CUSTOMER NOTIFICATION

SUD-DT-04-0093

PG-FP4

Operating Precautions

Figure 4-3. GUI Software Main Window

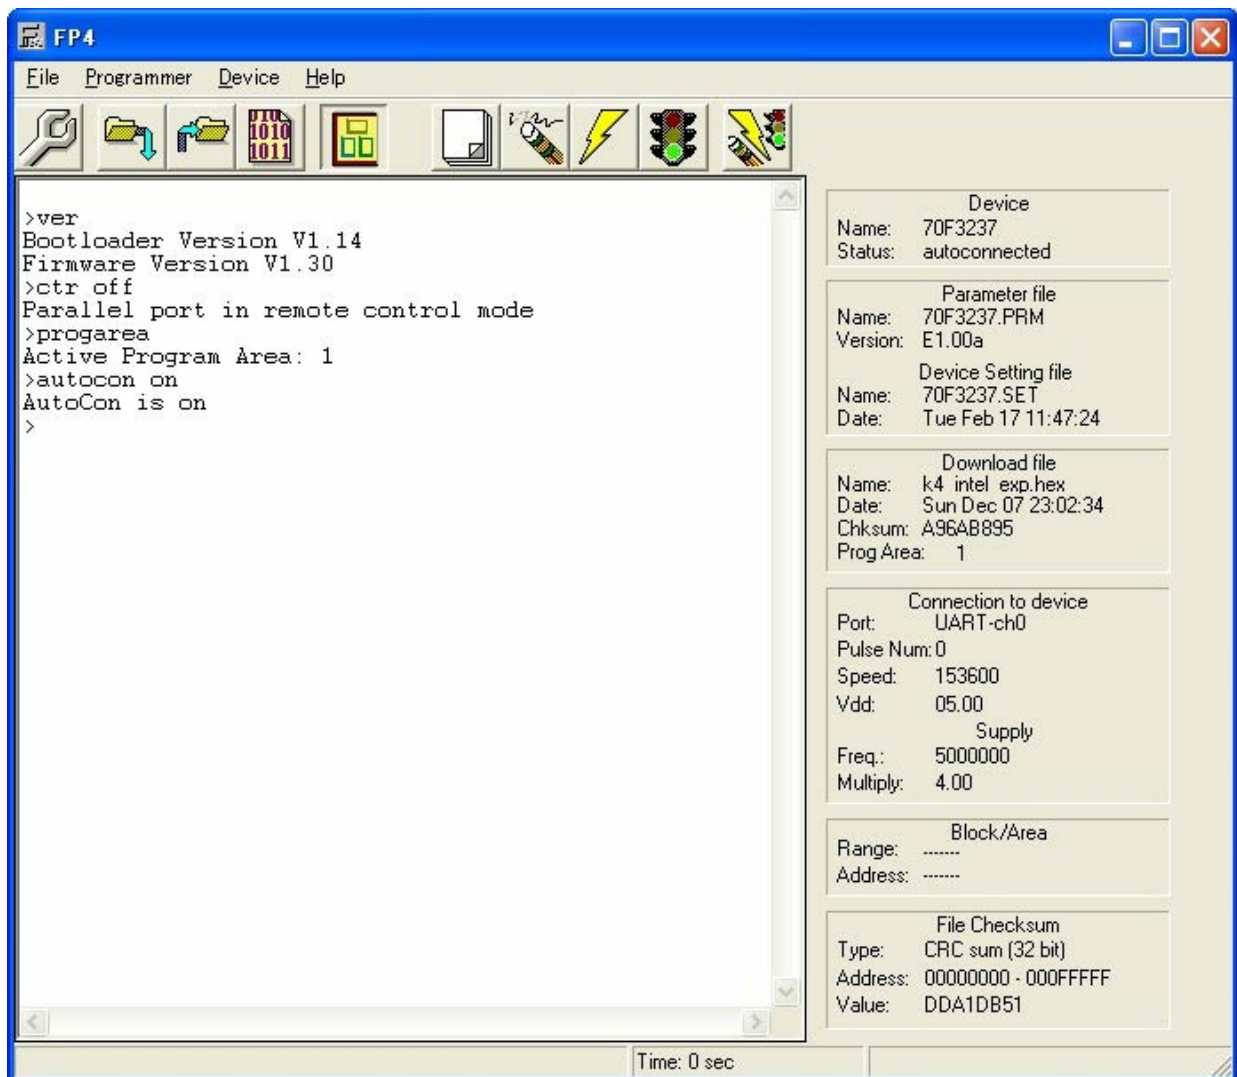
Change

Figure 4-10. Checksum Dialog Box

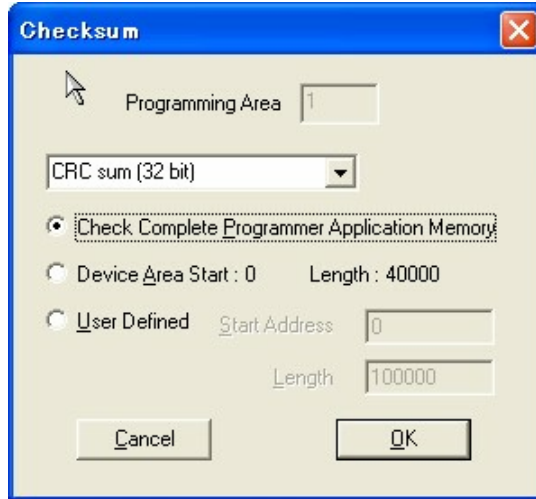
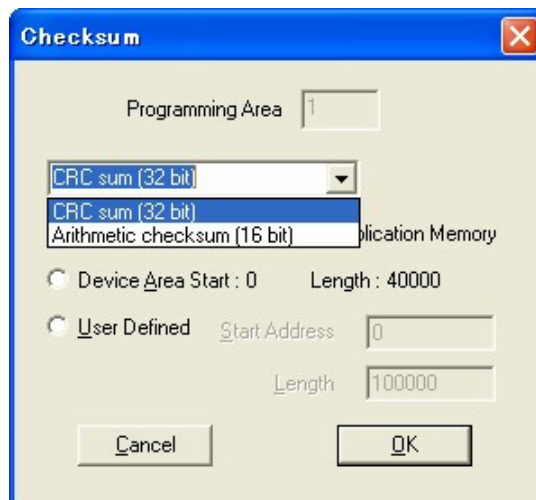
Change

All the programming memory area (2 MB) or “Check Complete Programmer Application Memory”, in which 32-bit CRC calculations are performed in the PG-FP4 programming memory area selected using the [Programmer] > [Select Programming area...] menu, is selected by default. A 16-bit arithmetic calculation can also be selected from the pull-down menu.

Figure 4-19. [Device] Menu

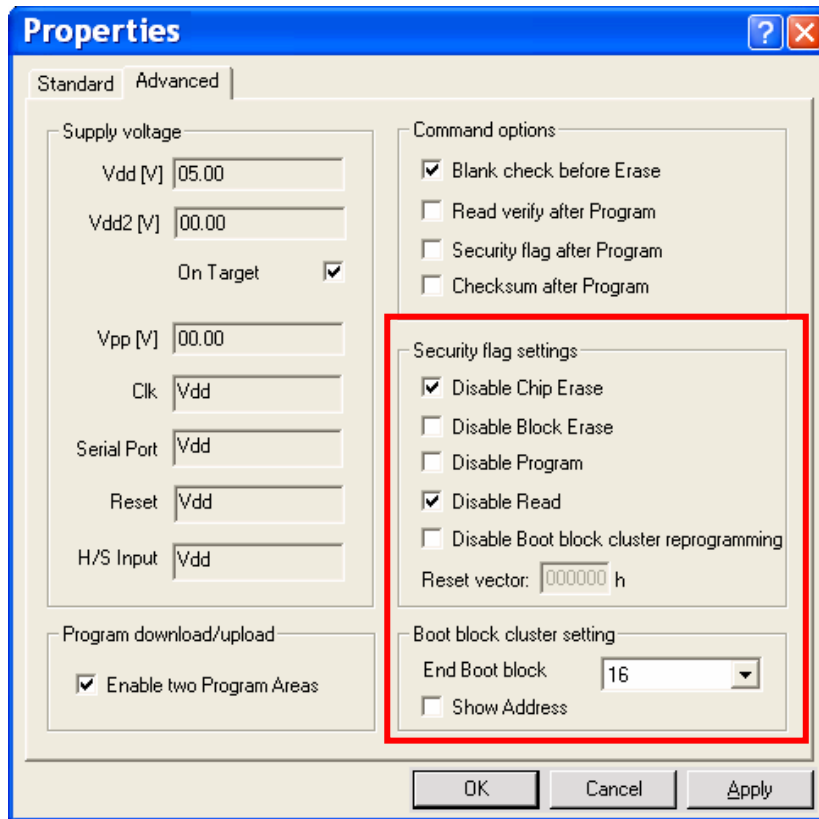
Change

Addition

The [Read] menu is used to read the flash memory of the target device connected to the PG-FP4. When [View] is selected from the [Read] menu, 4 KB read data is displayed in the log window each time the Enter key is pressed. When [Write Intel HEX File] or [Write Motorola SREC File] is selected from the [Read] menu, the read data can be saved in the Intel HEX-format or Motorola HEX-format.

Figure 4-26. Device Setup Window – Advanced

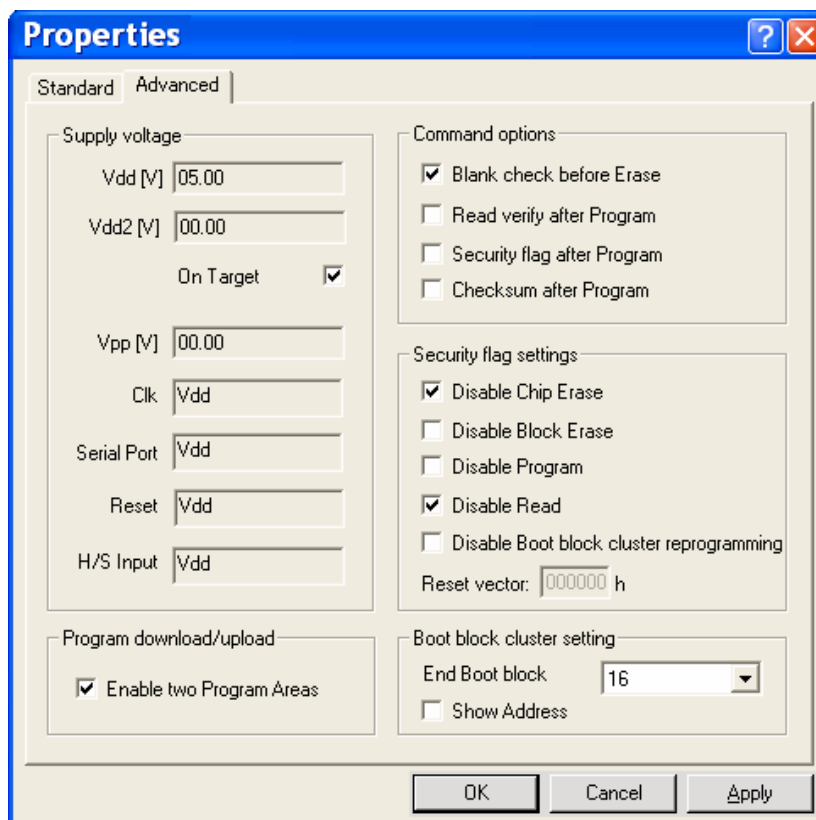
Change

Figure 4-29. Setup Window – Security Flag Settings

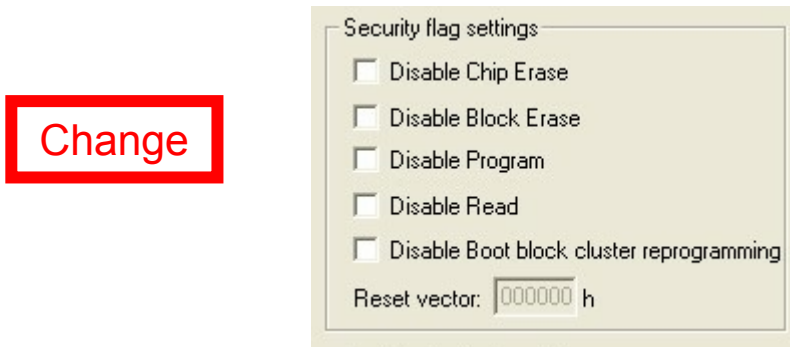
Change

[Disable Read check box]

If this check box is checked, the Read command becomes invalid.

Addition**[Disable Boot block cluster reprogramming check box]**

If this check box is checked, the boot area is set regarding the boot block set by the Boot block cluster setting function as the last block.
